TRANS/WP.29/605

ECONOMIC COMMISSION FOR EUROPE

Working Party on the Construction of Vehicles

DRAFT 01 SERIES OF AMENDMENTS TO REGULATION No. 94  
(Frontal collision protection)

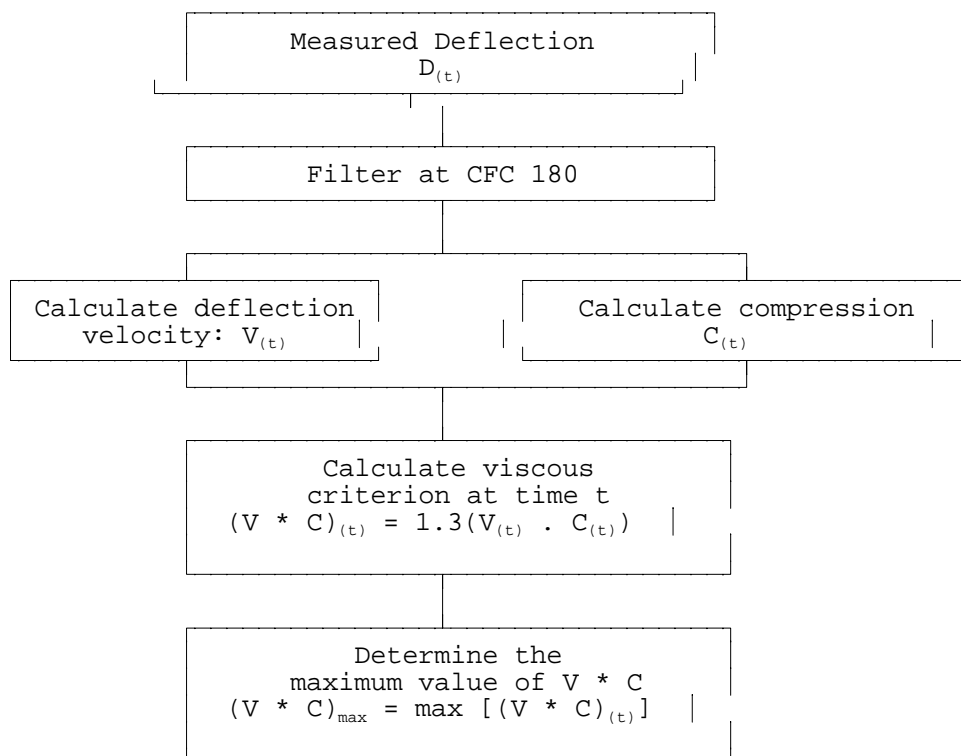
6. PROCEDURE FOR CALCULATING THE VISCOUS CRITERIA (V \* C) FOR HYBRID III DUMMY

6.1. The viscous criterion is calculated as the instantaneous product of the compression and the rate of deflection of the sternum. Both are derived from the measurement of sternum deflection.

6.2. The sternum deflection response is filtered once at CFC 180. The compression at time t is calculated from this filtered signal as:

$$C_{(t)} = \frac{D_{(t)}}{0.229}$$

The sternum deflection velocity at time t is calculated from the filtered deflection as:

$$V_{(t)} = \frac{8(D_{(t+1)} - D_{(t-1)}) - (D_{(t+2)} - D_{(t-2)})}{12\partial t}$$

where  $D_{(t)}$  is the deflection at time t in metres and  $\partial t$  is the time interval in seconds between the measurements of deflection. The maximum value of  $\partial t$  shall be  $1,25 \times 10^{-4}$  seconds. This calculation procedure is shown diagrammatically below:
